# Nationally Significant Infrastructure Project Cottam Solar Project

## Local Impact Report - October 2023

- 1.1 AAH Consultants (**AAH**) has been commissioned to prepare a review of the Landscape and Visual elements of the Development Consent Order (**DCO**) Application for the Cottam Solar Project (the '**Development**'), submitted to the Planning Inspectorate in January 2023, on behalf of Lincolnshire County Council (**LCC**). This follows on from AAH providing landscape and visual consultation with the developer and design team on behalf of LCC at the Pre-Application stage of the project, with AAH correspondence (in the format of Technical Memos) provided within **Appendix A**.

**Figure 7.11**  
Cottam 1  
Augmented ZTV

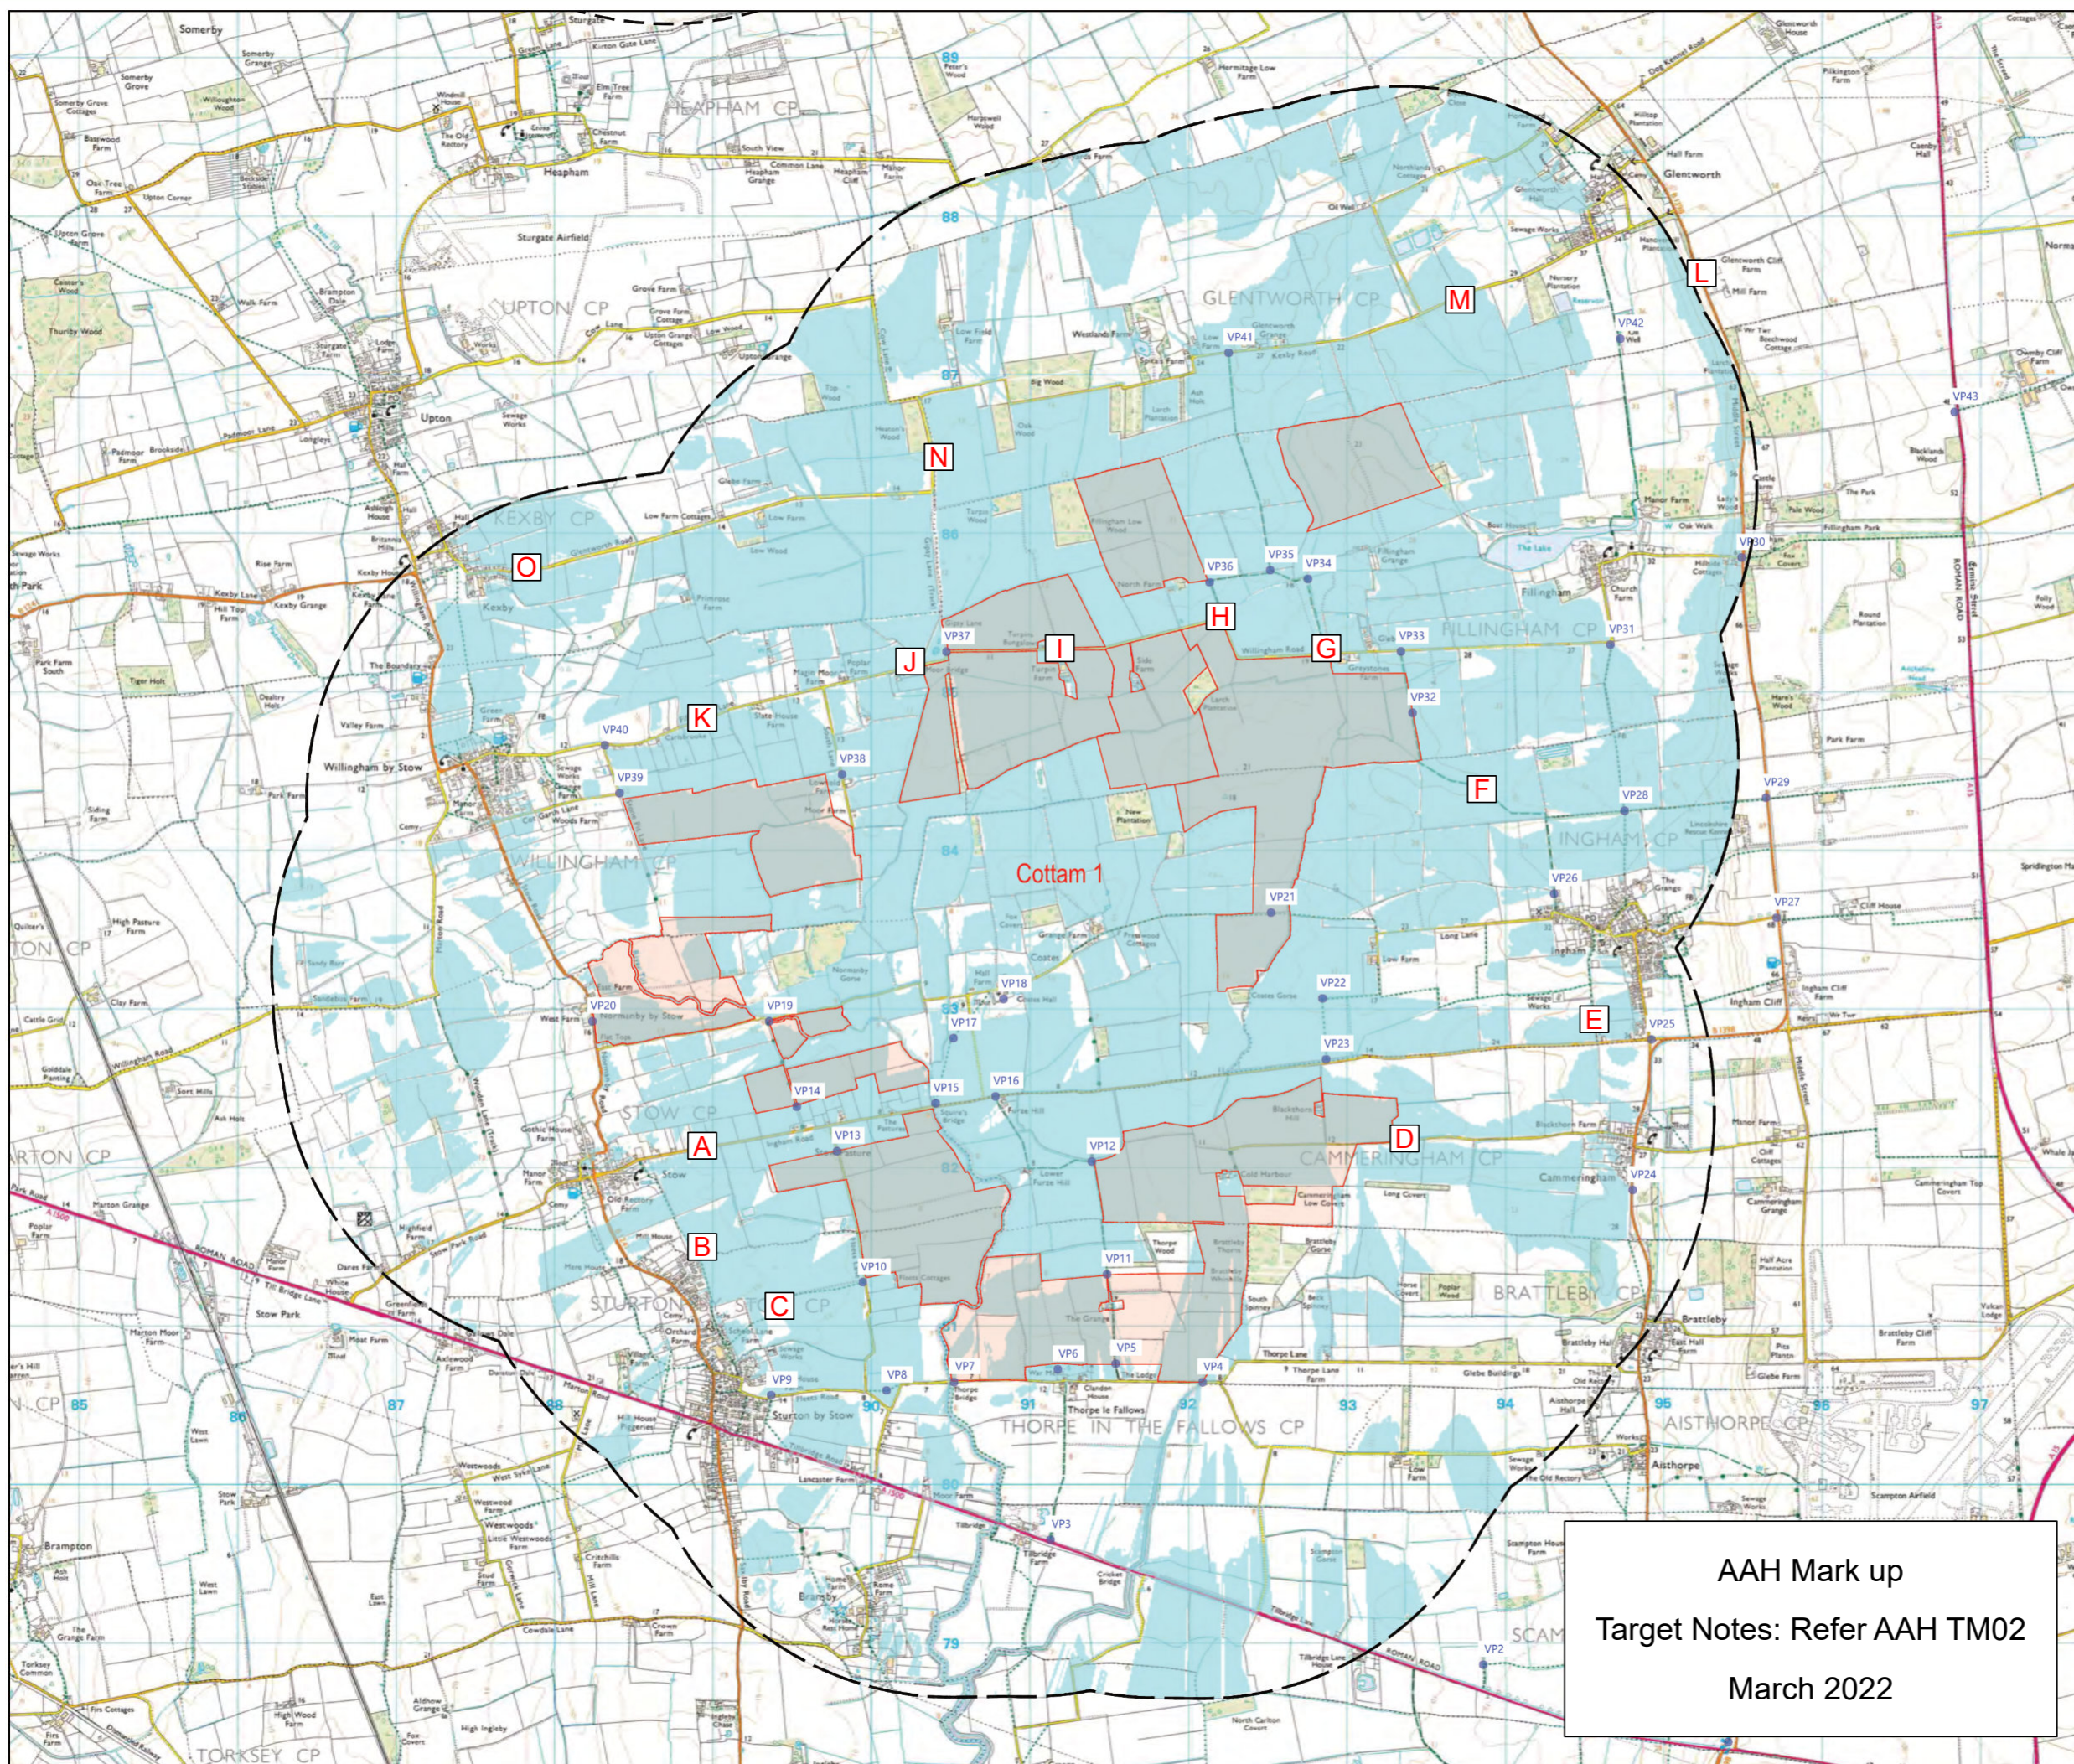
As shown on mark up Figure 7.11 Cottam 1 Augmented ZTV

**Figure 7.12**  
Cottam 2  
Augmented ZTV

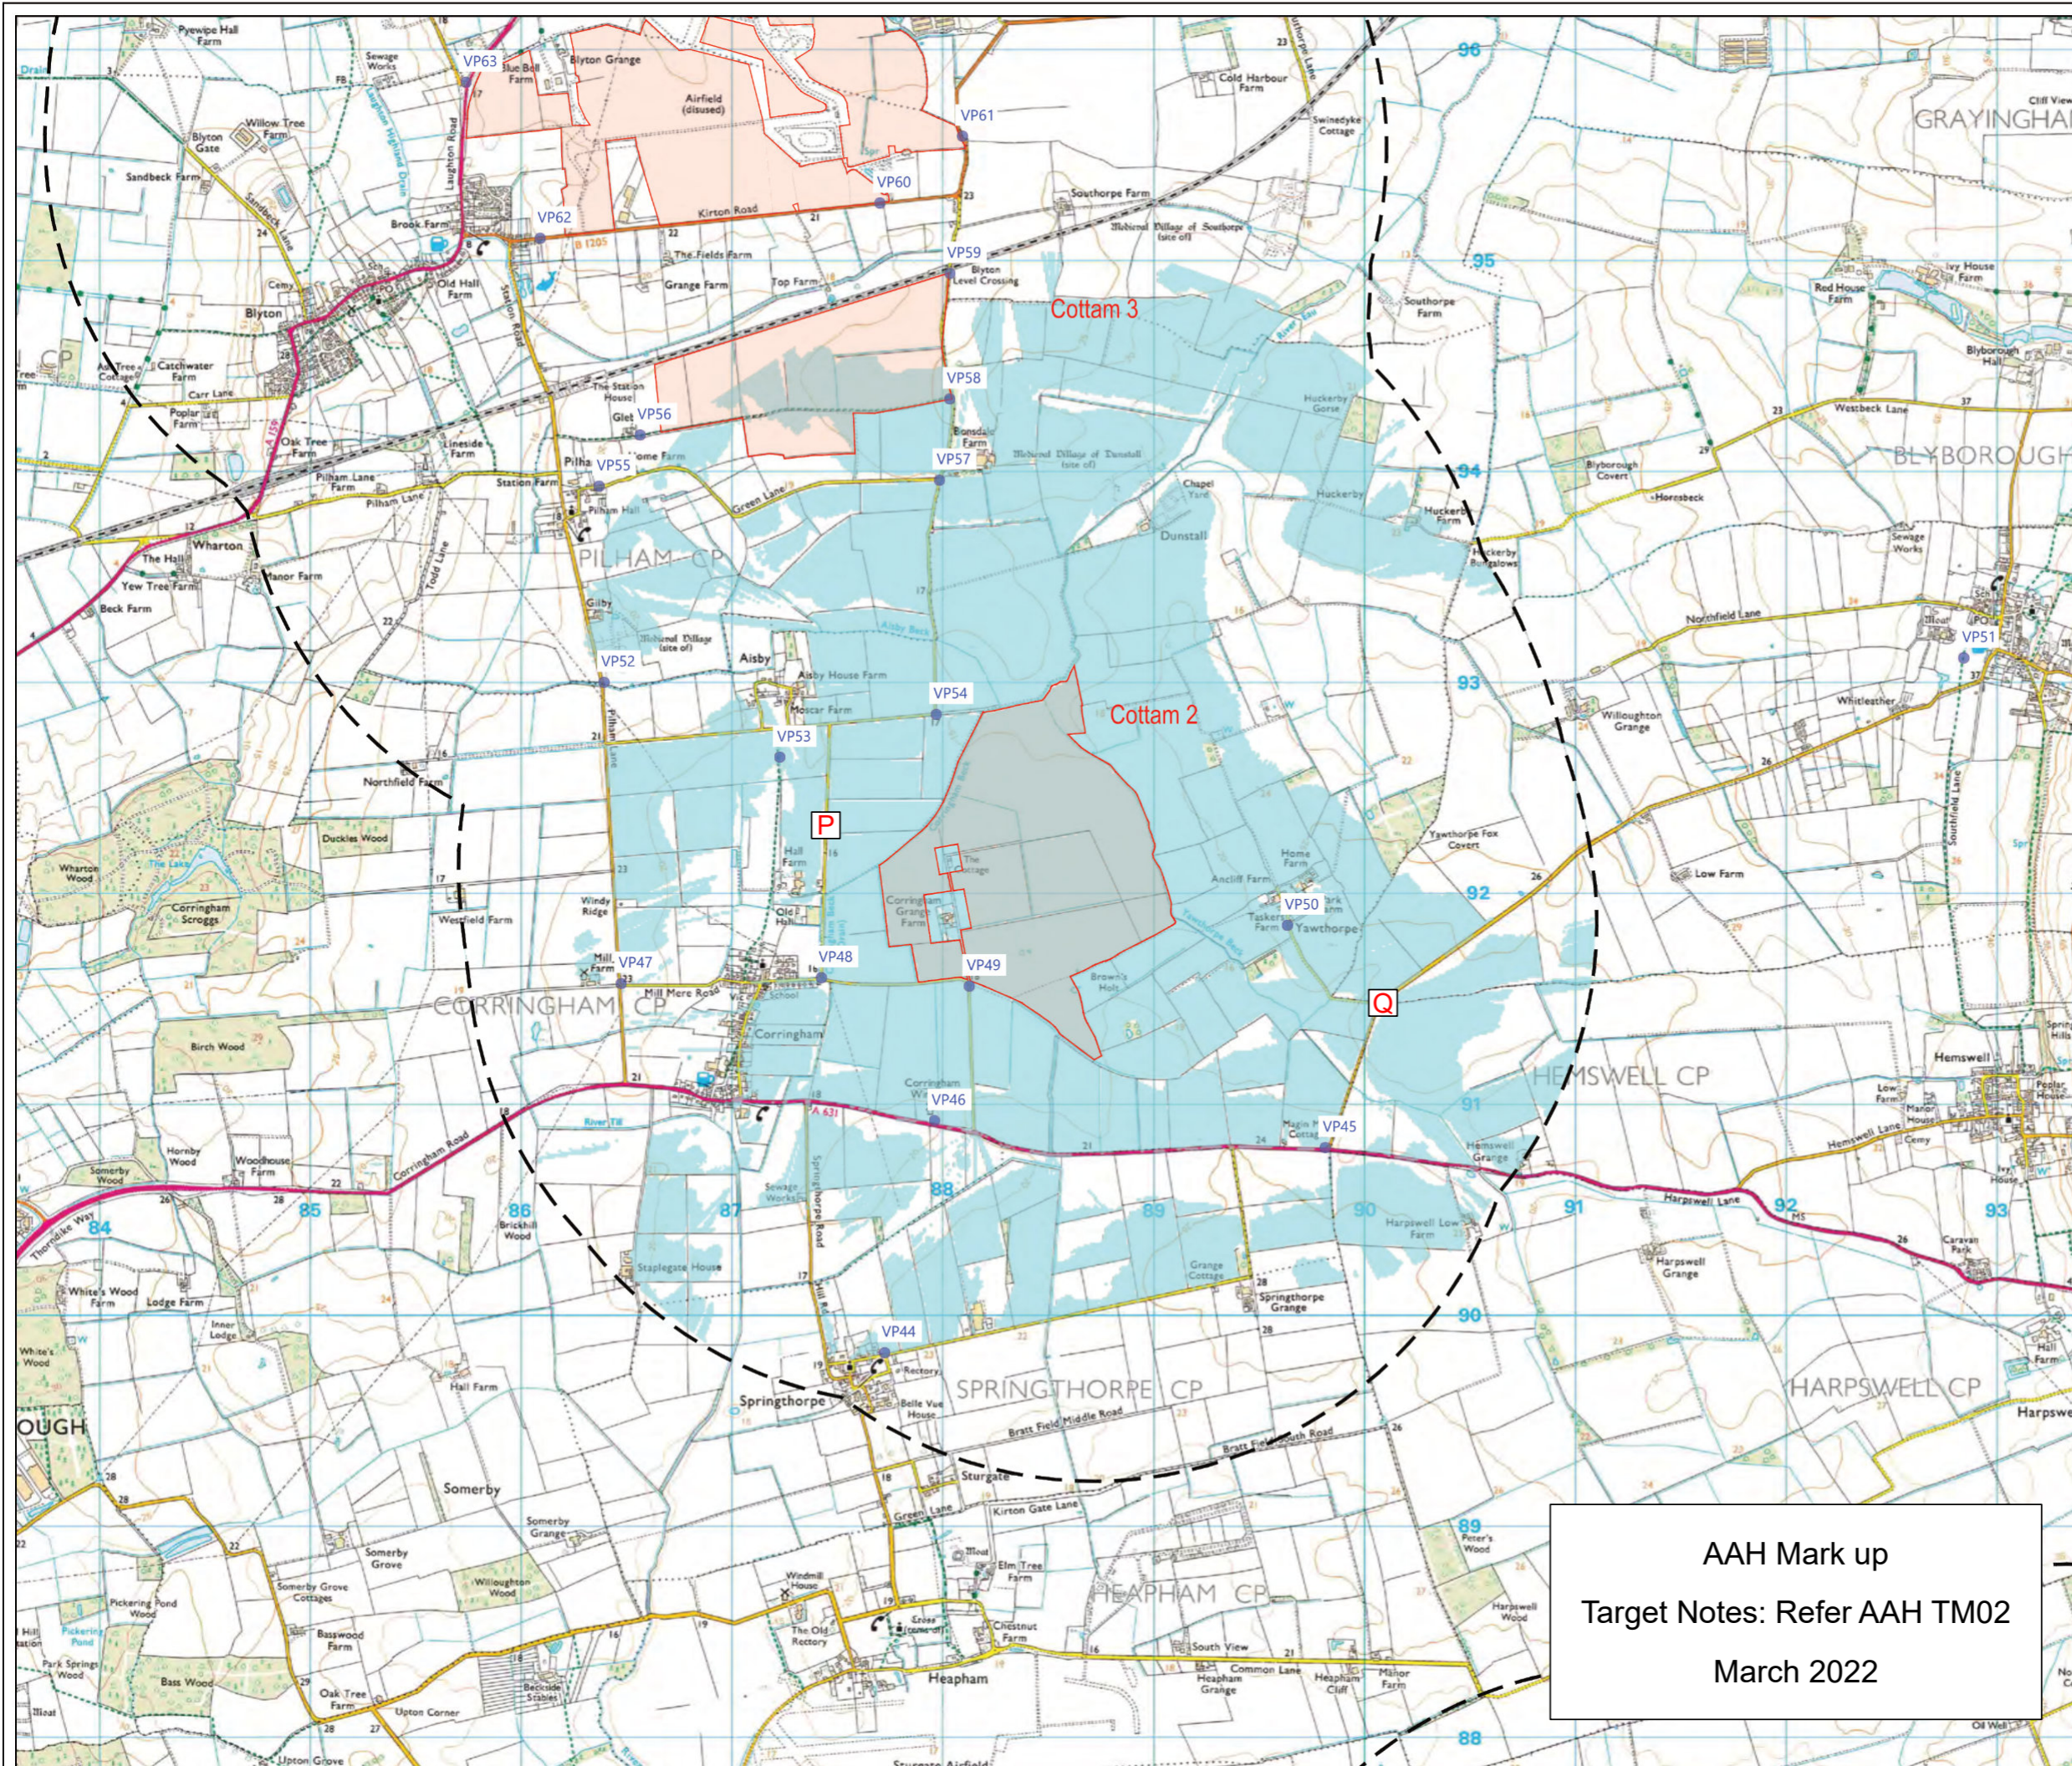
As shown on mark up Figure 7.12 Cottam 2 Augmented ZTV

AAH Mark up  
Target Notes: Refer AAH TM02  
March 2022
